Determination 2017/035

Regarding the refusal to issue a code compliance certificate for an 18-year-old house at 1135 Telegraph Road, Darfield

Figure 1: Approximate plan

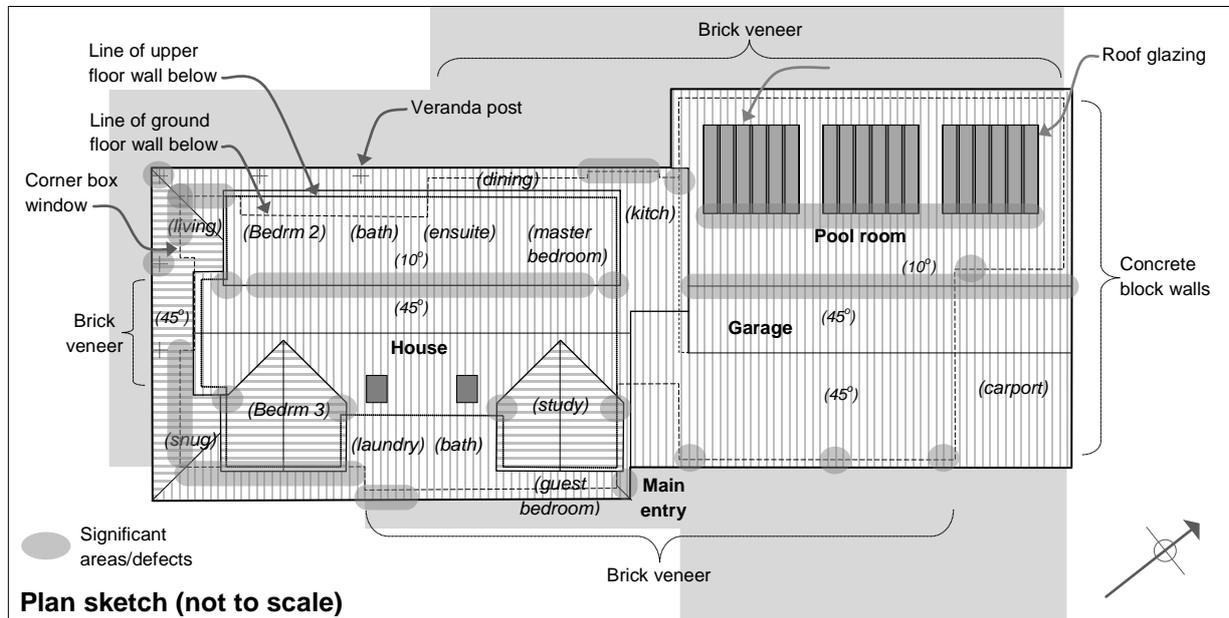
- 5.7.1 The expert inspected the external building envelope of the house, taking into account the age of the building work and the risks applying for particular junctions and intersections. (Refer to Figure 1 for locations of significant observations.)

- 5.7.3 Commenting specifically on the external envelope in regard to the authority's concerns, the expert noted:
- although vent holes had been installed, many are from 30mm to 50mm above the paving – resulting in lips that prevent complete drainage (Item 1 and part 2)

- the bottom of the weatherboard at the west box window is buried in the paving and has decayed, with further decay likely in the framing behind (Item 2)

- soil is above the bottom of weatherboards along southeast (Item 2)
 - the bottom of the garage door reveal contacts the paving, with obvious decay in the reveal closest to the carport (Item 4)

- the ends of head flashings at the junction of the pool room skylights with the low pitched roof are poorly flashed and heavily reliant on sealants (Item 16)

- the raised 'step' at the head of the skylight perimeter allows significant debris to accumulate against the head flashing – allowing water to overflow into the roof cavity, with visible damage to plasterboard linings below (Item 16).

- The incorrect lap at the south end of the barge flashing above bedroom 2, with split sealant and gaps that allow moisture to penetrate into and damage areas of the underlying roof framing (see paragraph 5.4.2).
- The incorrect lap at the east end of the barge flashing above the master bedroom – although that sealant has remained intact to date and there is no sign of moisture penetration into the roof space to date.
- No flashing to the change in roof pitch above bedrooms (see paragraph 5.4.2).

- Damaged timber roof framing below the south end of the barge flashing above bedroom 2 (B1, B2).
- The change in roof pitch above the bedrooms (E2, B2).
- The upper end of the pool room skylights (E2, B2).
- The lack of effective drainage from the brick veneer cavities (E2, B2).
- The lack of ground and paving clearances to many areas (E2, B2).

- Decay (B2) to:
 - the weatherboards under the box window
 - the bottom of the veranda posts
 - the garage door reveal.
